CITY OF AUSTIN – DEVELOPMENT SERVICES DEPARTMENT
SITE PLAN APPLICATION – MASTER COMMENT REPORT

CASE NUMBER: SP-2020-0246C.SH
REVISION #: 00
CASE MANAGER: Clarissa E. Davis
UPDATE: U1
PHONE #: 512-974-1423

PROJECT NAME: Zilker Studios
LOCATION: 1508 S LAMAR BLVD

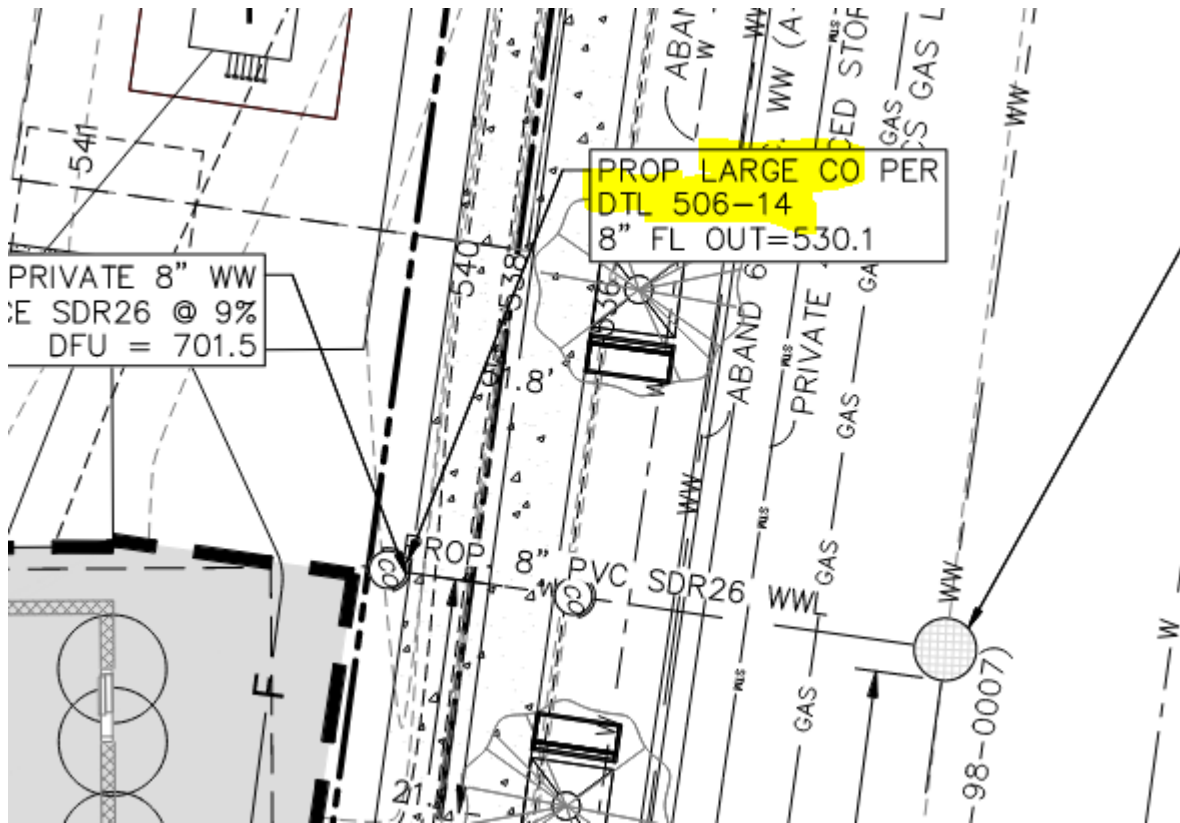
IW1. Reference detail AW-SPECIAL-01 in the call-out for the large diameter cleanout and include the detail in the utility detail sheets.

U1: Comment stands. Revise the highlighted call-out to show "large diameter cleanout per dtl 506-AW-04" and replace AW-SPECIAL-01 with Standard Detail 506-AW-04 (effective August 14, 2020) in the utility detail sheets.

Response: The large diameter cleanout is added to Sheet 16: Details (3 of 3).
